SUBJECT: Revised Submittal of Quality Assurance Program for
Station Operation
R. E. Ginna Nuclear Power Plant
Docket Number 50-244

In accordance with 10 CFR 50.54(a)(3), enclosed is Revision 29 to the Quality Assurance Program for Station Operation (QAPSO) for the R.E. Ginna Nuclear Power Plant. Revision 29 incorporates the following changes:

ATTACHMENT 1

FIGURE 17.1.2-1

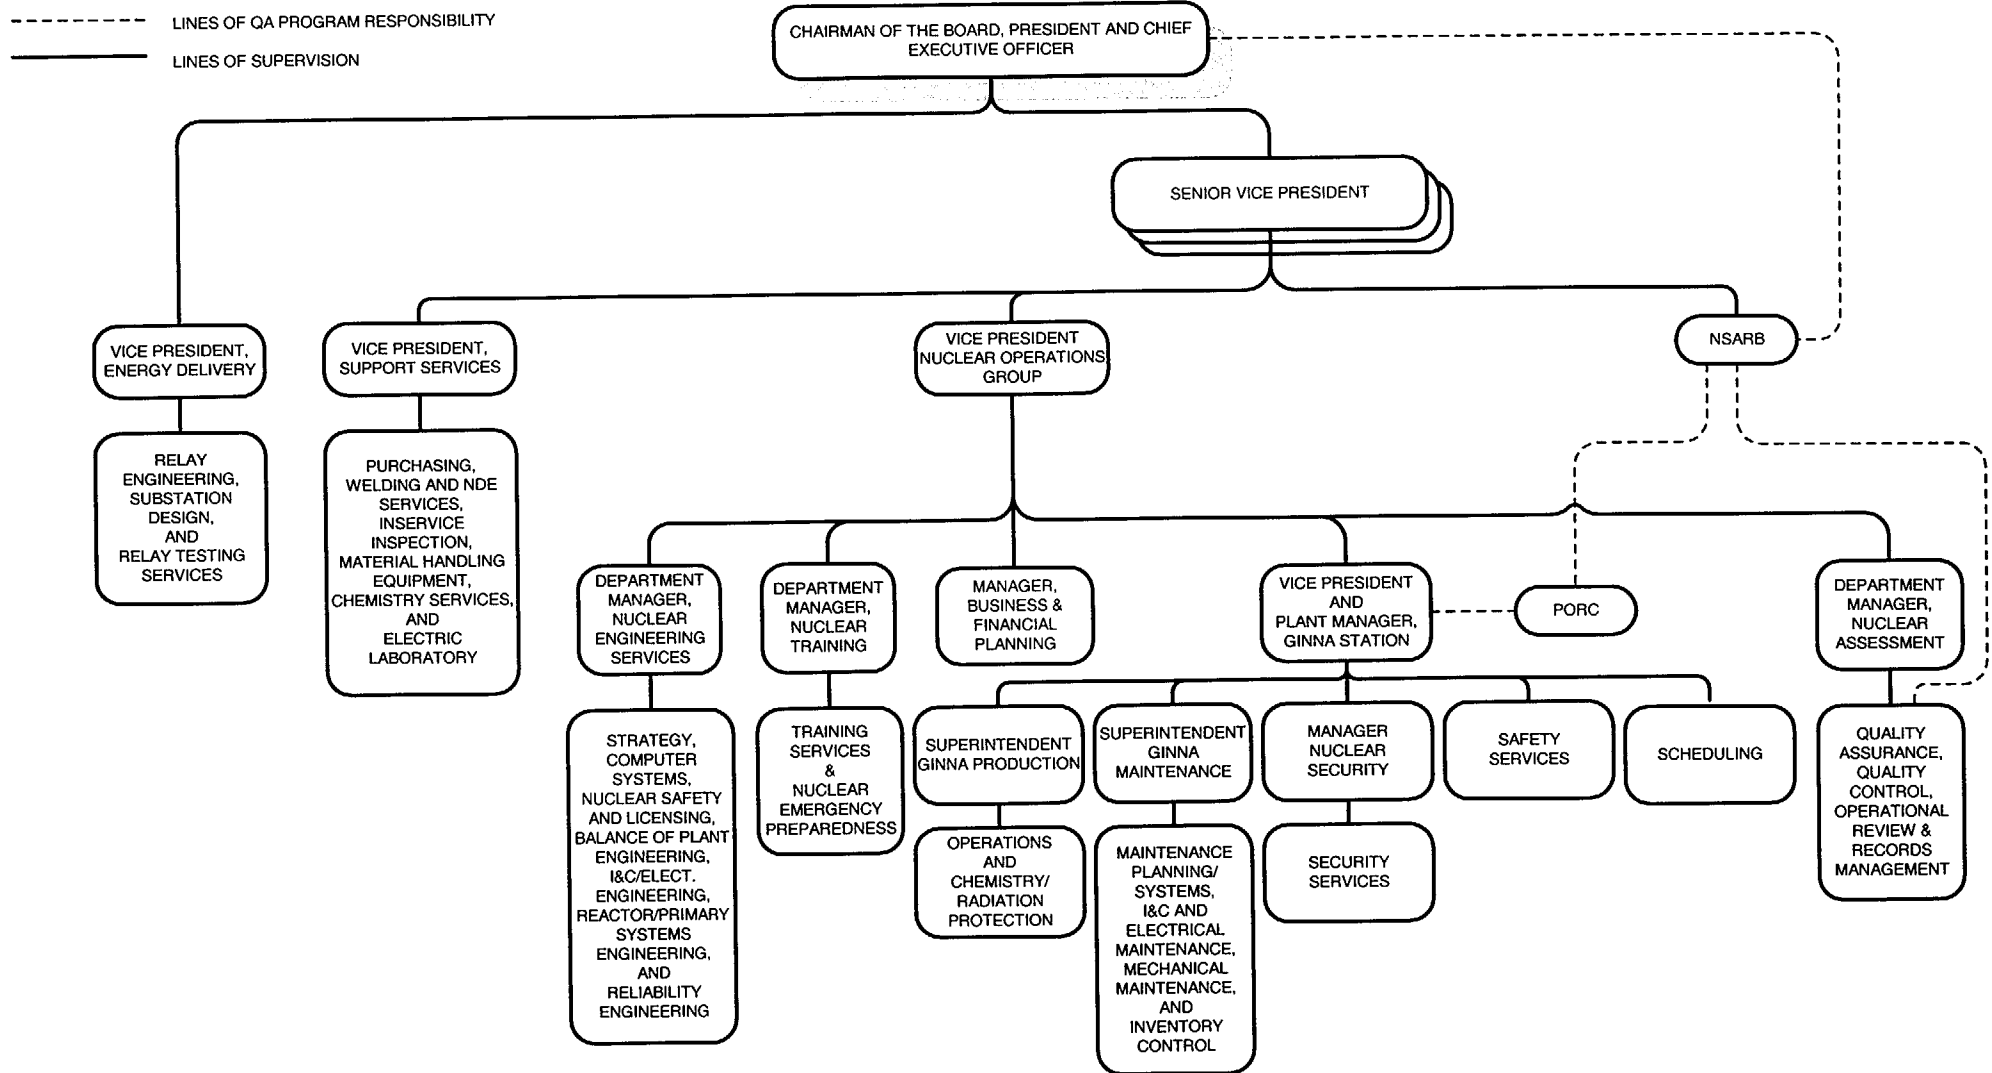
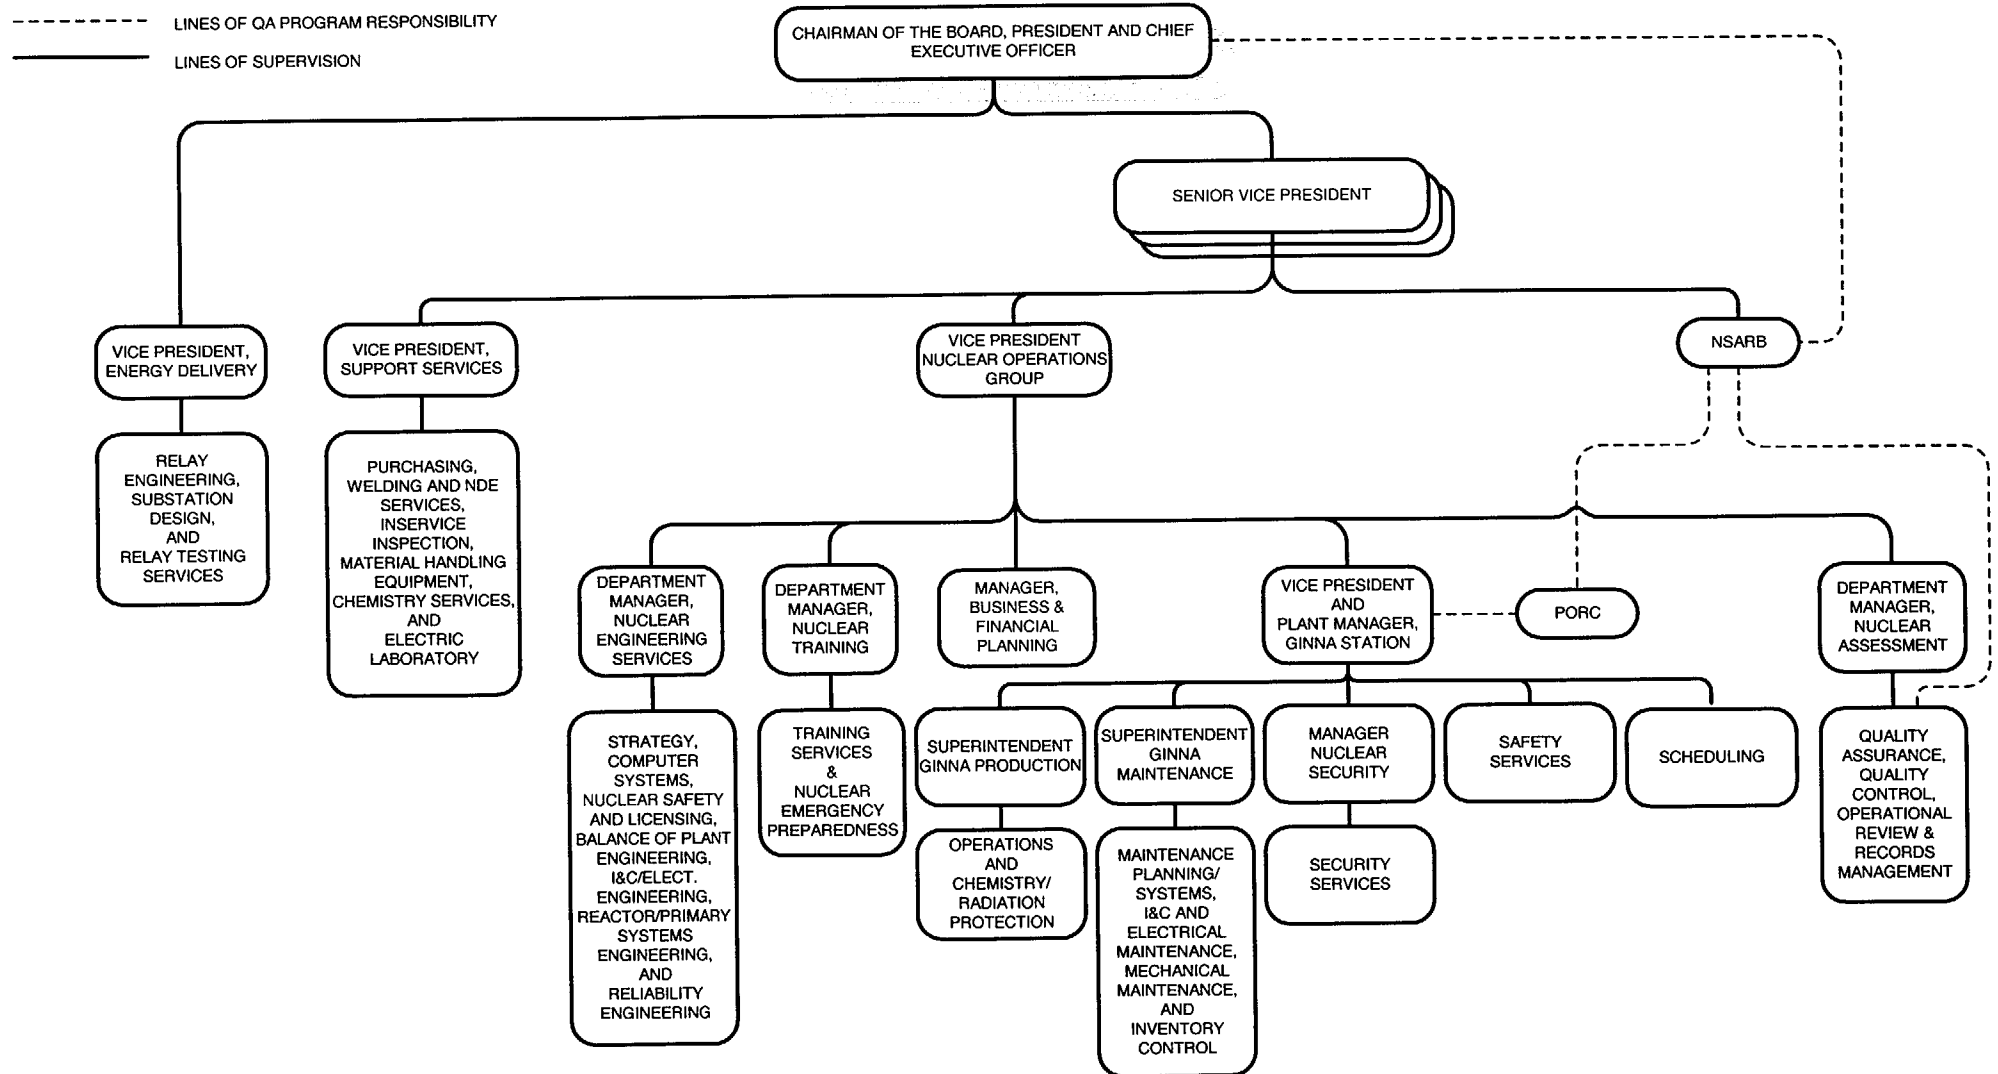
The following organization changes are reflected throughout the text of the document and on the Figure 17.1.2-1 Organization Chart:

1. A reorganization of Nuclear Engineering Services resulted in the elimination of the Configuration Support Section.
2. Changed the title of "Director, Budget and Cost" to "Manager, Business and Financial Planning".
3. Removed the Senior Vice President, Corporate Services from the Ginna organization structure.
4. Revised wording to clarify NSARB responsibility for directing and evaluating internal audits.
5. Changed title of "Senior Vice President, Generation" to "Senior Vice President" and "Supervisor, Nuclear Security" to "Manager, Nuclear Security."
6. The responsibility for review of INPO documents and NRC Information Notices has been transferred from Nuclear Safety & Licensing to Operational Review.
